UNITED STATES PATENT AND TRADEMARK OFFICE

APPLICATION NO.	FILING DATE	FIRST NAMED INVENTOR	ATTORNEY DOCKET NO.	CONFIRMATION NO.
10/715,669	11/18/2003	Jerome Glasser		4813
40232	7590	04/12/2007		
JEROME GLASSER 16 SUNSET TERRACE MAPLEWOOD, NJ 07040			EXAMINER SANDY, ROBERT JOHN	
			ART UNIT	PAPER NUMBER
			3677

Office Action Summary	Application No.		Applicant(s)	
	10/715,669		GLASSER, JEROME	
	Examiner		Art Unit	
	Robert J. Sandy		3677

DETAILED ACTION

FIG. 49

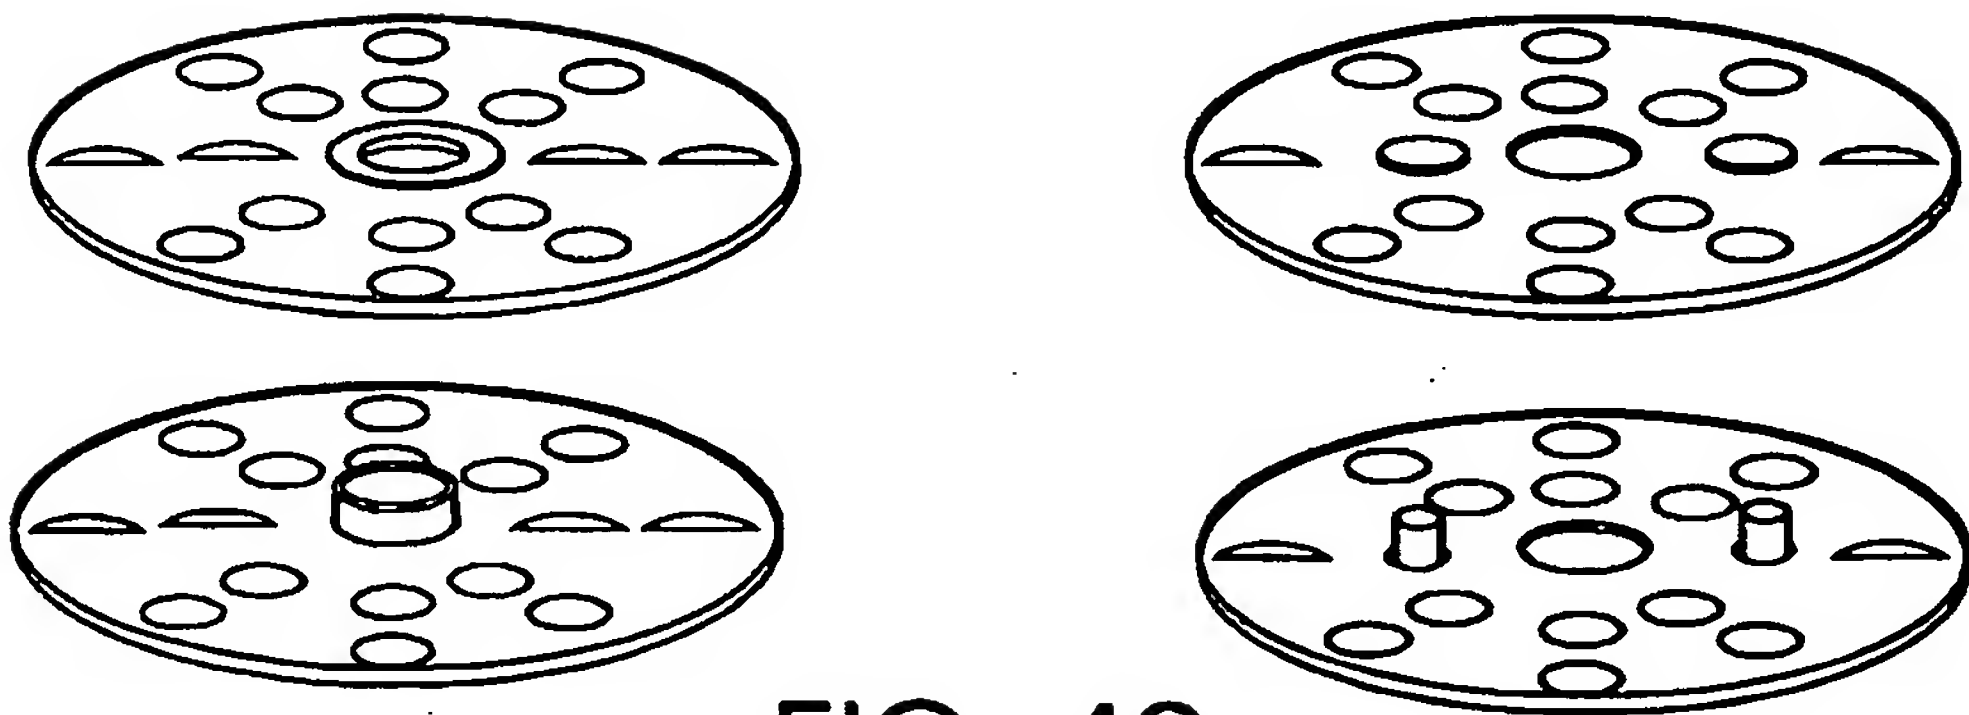
The original disclosure provided no support for the brief description of (new) Fig. 49 (formerly original Fig. 57) regarding the added text of “permitting the joining of a front and back plate at a hub without glue or sonic welding.”

Applicant is required to cancel the new matter in its entirety in the reply to this Office Action.

FIG. 53

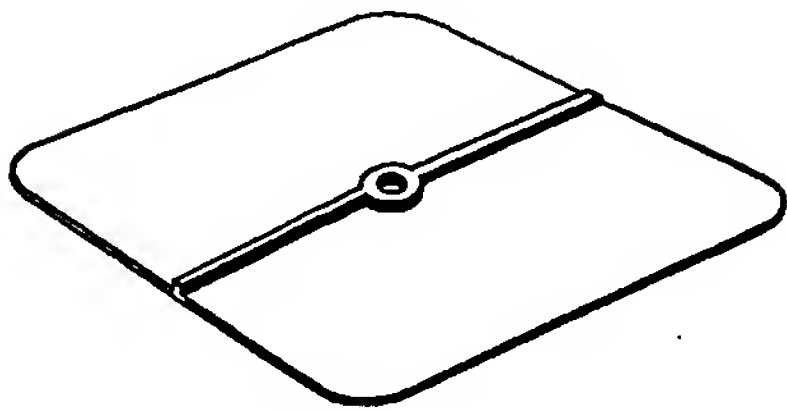
The original disclosure provided no support for the brief description of (new) Fig. 53 (formerly original Fig. 61) regarding the subject matter pertaining to the added underlined text of “NFIG. 53 is a perspective view of a back plate of clamp-like clip with a tack hole.”

FIG. 54

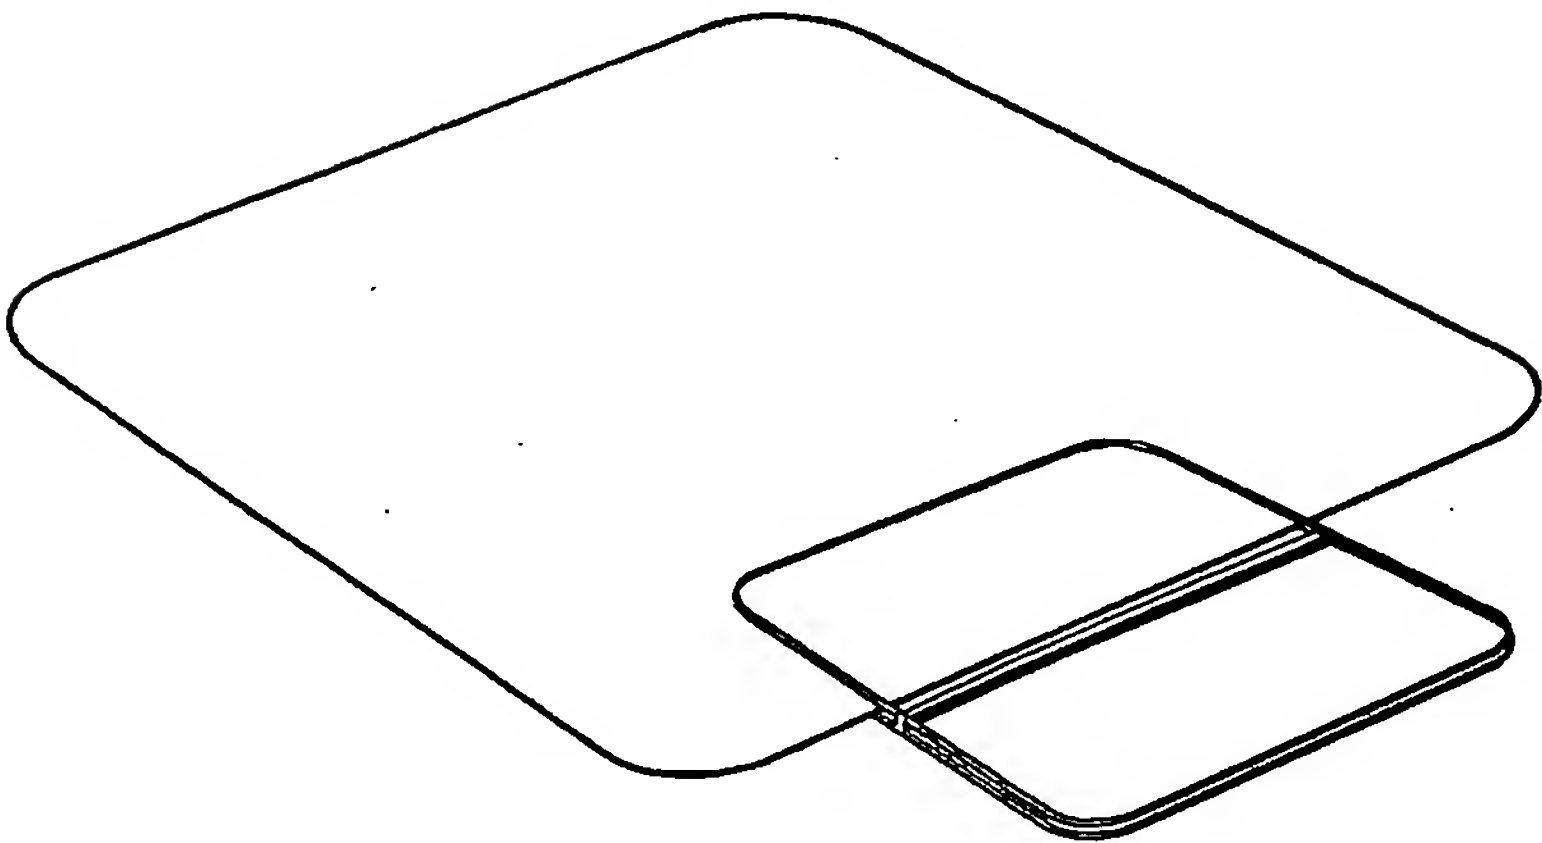
The original disclosure provided no support for the brief description of (new) Fig. 54 (formerly original Fig. 62) regarding the subject matter pertaining to the added underlined text of “NFIG. 54 is the embodiment of NFIG. 53- without tack hole and holding a card-like display item.”
